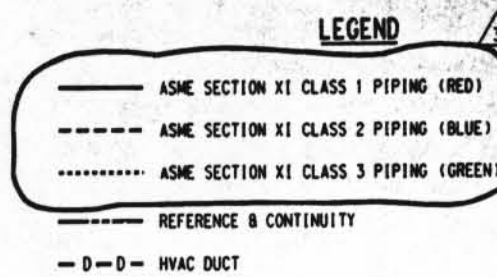
INFO. NOTE:  
(REMOVE AT NEXT UPDATE)  
REVISION CHANGE IN THE CLOUDED  
AREA WAS FOR COLORIZING THE  
LINE CLASS CODES

INFO. NOTE:  
(REMOVE AT NEXT UPDATE)  
REVISION CHANGE IN THE CLOUDED  
AREA WAS FOR COLORIZING THE  
LINE CLASS CODES

INFO. NOTE:  
(REMOVE AT NEXT UPDATE)  
REVISION CHANGE IN THE CLOUDED  
AREA WAS FOR COLORIZING THE  
LINE CLASS CODES
